ADDENDUM NO. 1

for
**ALTERATIONS AND RENOVATIONS TO JOSEPH C. SHANER MEMORIAL
ELEMENTARY SCHOOL AND WILLIAM DAVIES MIDDLE SCHOOL**

Issued: March 5, 2019

FVHD PROJECT #4937B /NJDOE #1940-060-18-1000
Shaner Memorial Elementary School, 5801 Third St., Mays Landing, NJ 08330

Drawing Number
A001a

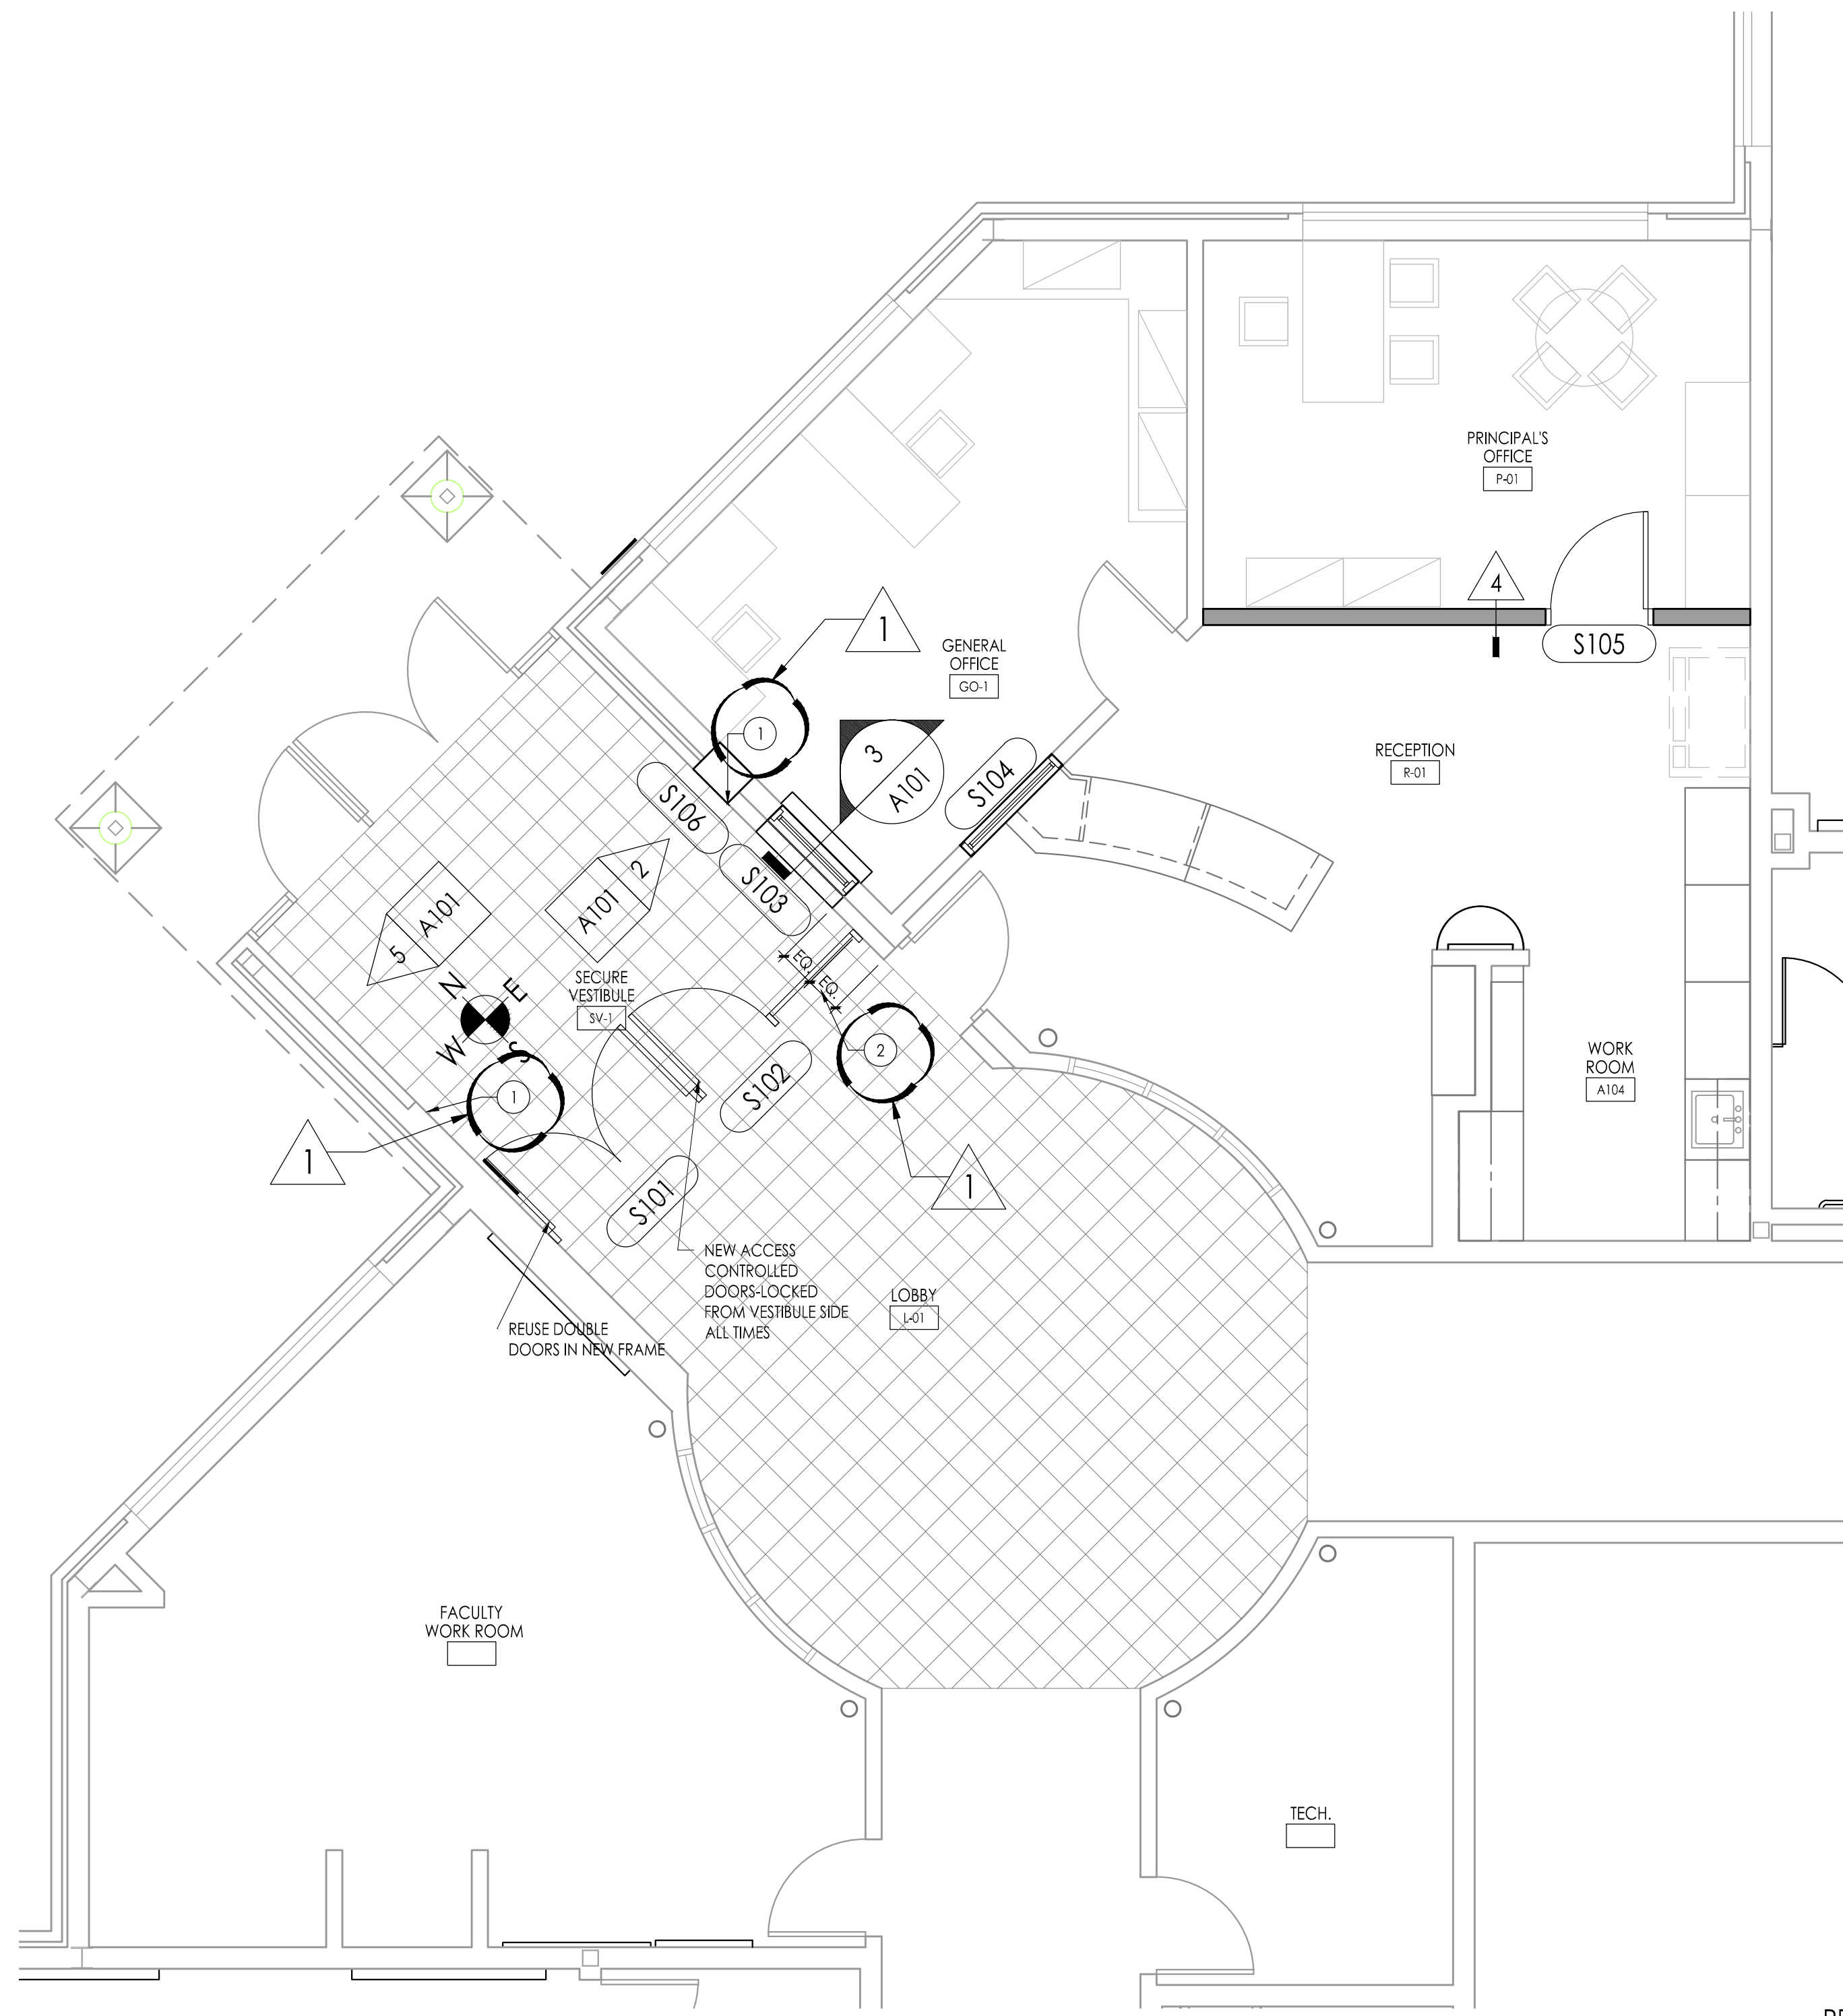
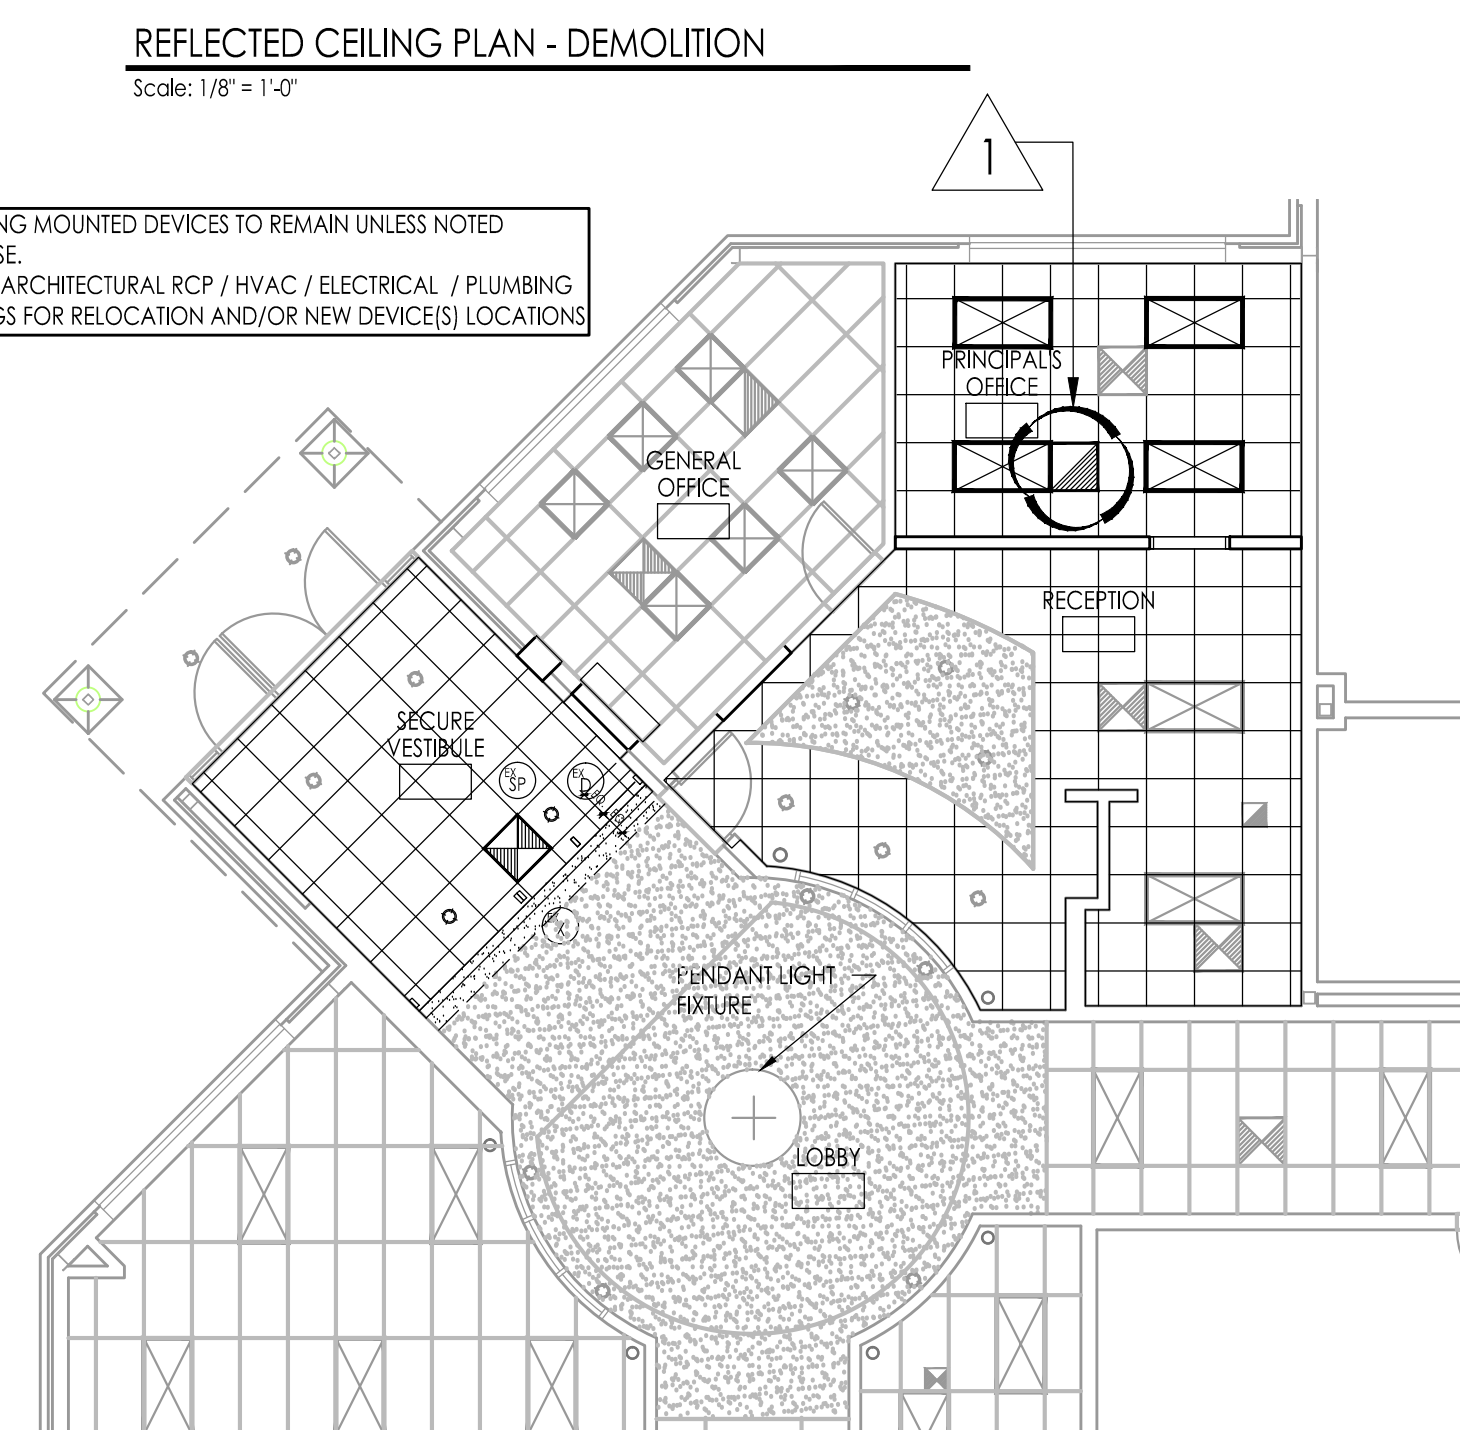
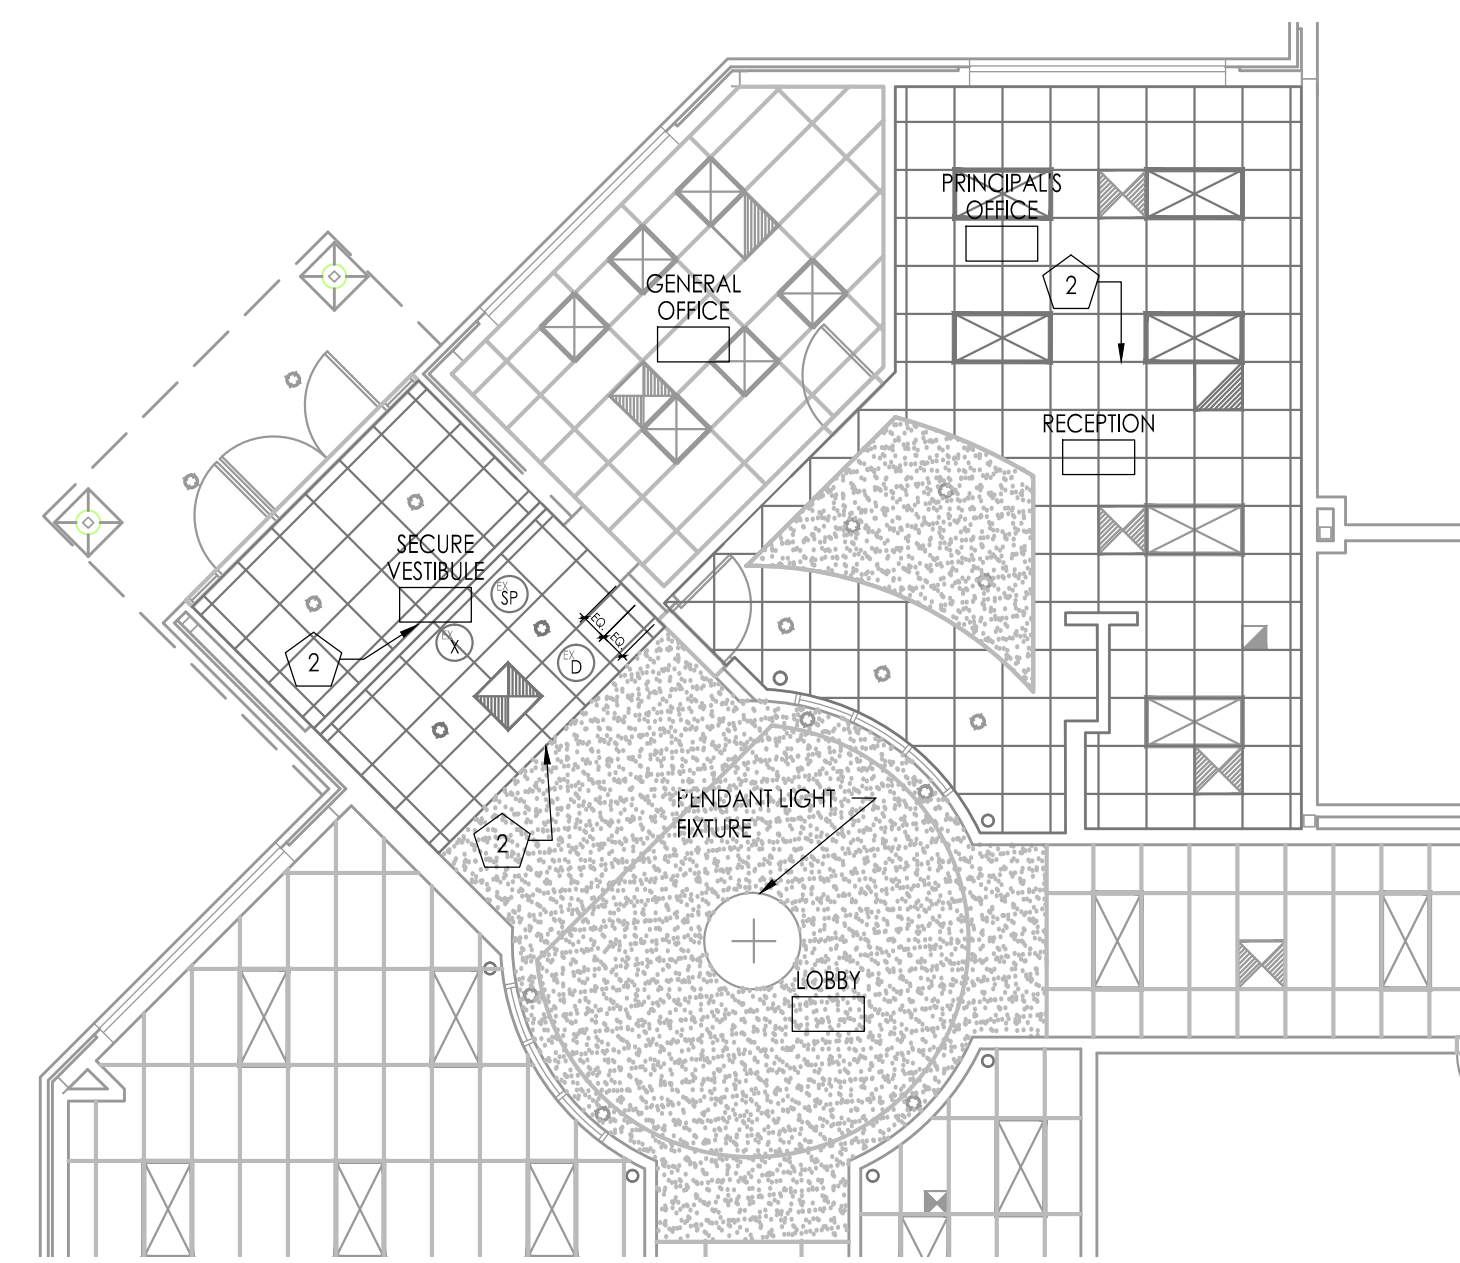
Drawing Name
PHASING
PLAN

No.	Date	Description
1	03.05.19	ADDED BY ADDENDUM #1
